Fact Sheet for State Waste Discharge Permit No. ST0045515

Edison Wastewater Treatment Facility Skagit County – Edison Clean Water Subarea

Appendix E—Response to Comments

Depth to Groundwater Monitoring Data, March 2013 to December 2014

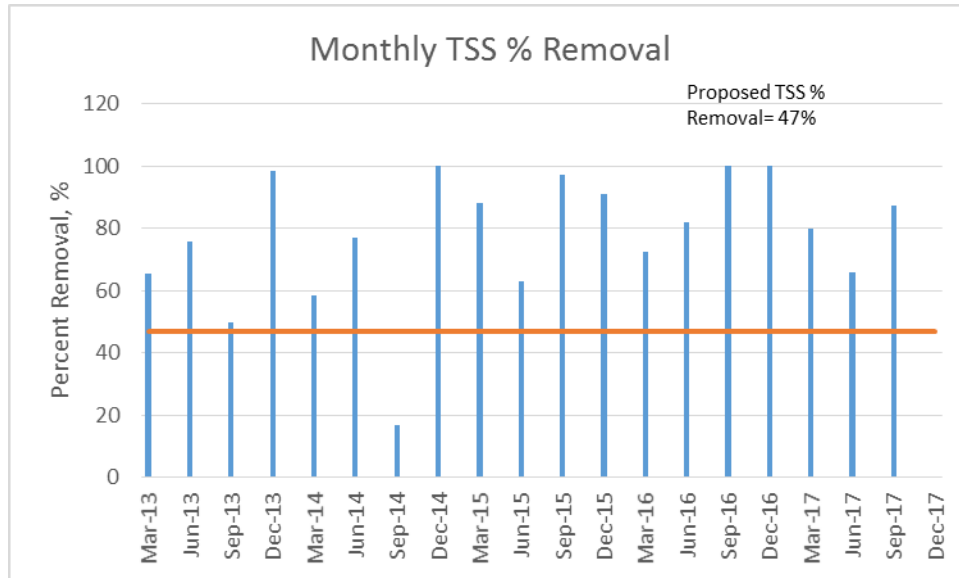
4. Fact Sheet, Page 16. Under Emergency Upflow Trench, what does superscript "a" refer to.
5. Fact Sheet, Page 51. This table used well designations P10, P11, and P8. The Groundwater Assessment Report, Figure 6, used completely different well ID's. No where in the Fact Sheet or Permit are the locations of P10, P11 or P8 shown nor could I locate the reference. Some of the information shows high groundwater at times for certain wells. However, nothing actually confirms high groundwater in the trenches. Checking the water level at the cleanouts for each trench would confirm if groundwater is at, or above, trench level. **Note: Fig. 2 of previous Fact Sheet (2013) shows the location of P10, P11, and P8. The current Fact Sheet does not.**
